United States Nuclear Regulatory Commission Official Hearing Exhibit	
In the Matter of:	CROW BUTTE RESOURCES, INC. (License Renewal for the In Situ Leach Facility, Crawford, Nebraska)
	ASLBP #: 08-867-02-OLA-BD01
	Docket #: 04008943
	Exhibit #: CBR-020-00-BD01
	Admitted: 8/18/2015
	Rejected:
Other:	Identified: 8/18/2015 Withdrawn: Stricken:

August 26, 2010

**RE: RESPONSE TO NDEQ EXCURSION MONITORING ISSUES**

**Figure 1. Water Balance in WH45/47 and Chloride Concentration in CM9-3  
October 2007 Through June 2008**

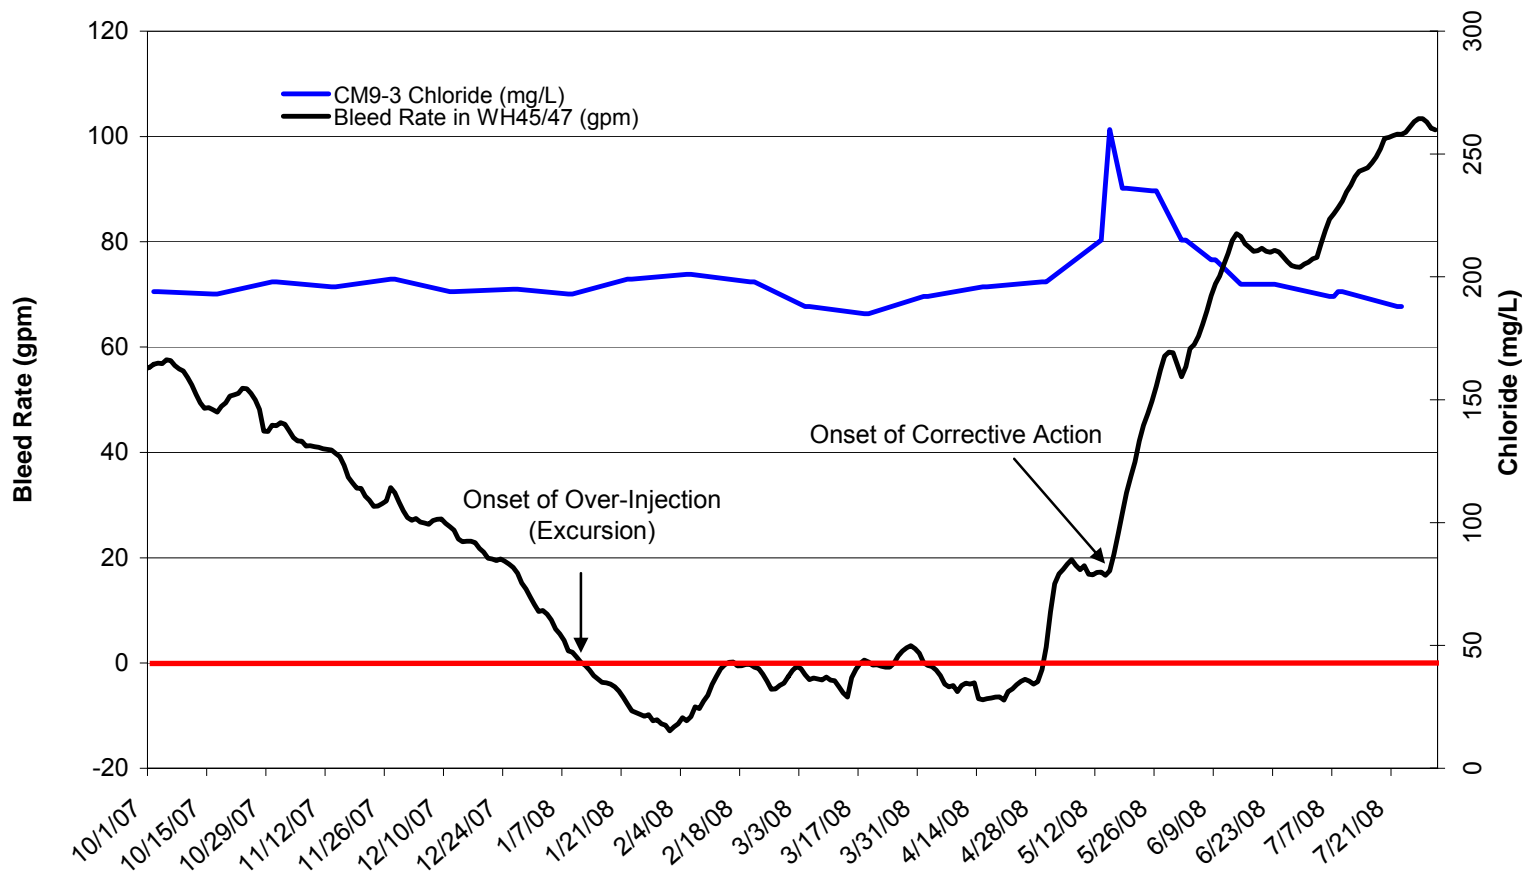
In the case of the May 2008 excursion in MU9, water balance data collected from Well Houses 45 and 47 (WH45/47) indicates that a local over-injection of mining solutions began in the first week of January 2008 and continued sporadically through the end of April 2008 (Figure 1). The average rate of over-injection in WH45/47 during this period was approximately 12 gallons per minute (gpm). The onset of the excursion was reflected as a rise in water level in the adjacent monitoring well ring during this time, including excursion monitoring wells CM9-3 and CM9-5 (Figures 2 through 10).

In response to the May 2008 excursion event, CBR began excursion corrective action by curtailing injection and increasing the extraction rate from perimeter production mining wells in WH45/47. Excursion corrective action was initiated immediately on May 15, 2008 as shown in Figure 1.

**Figure 11. Effects of  $K_d$  Values on Constituent Transport**

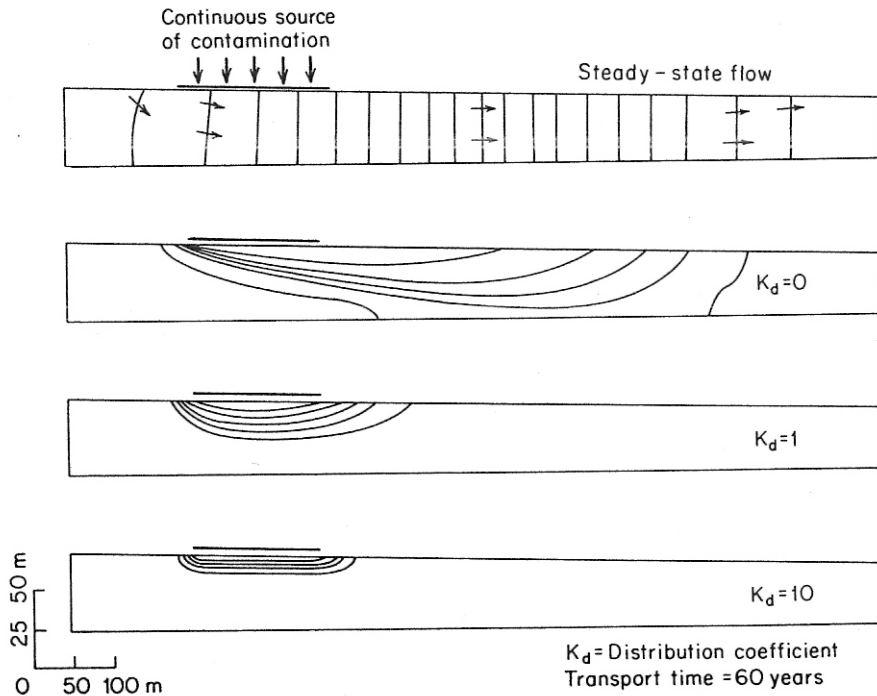
A high  $K_d$  ( $> 10$  ml/g) indicates that a constituent is strongly retained by the aquifer solids and will travel much more slowly than the average groundwater velocity. Even a constituent with a relatively small  $K_d$  (e.g., equal to 1 ml/g) will be transported through groundwater much more slowly than a constituent that is not retained by the solid phases ( $K_d$  equal to 0 ml/g), as illustrated by Figure 11.
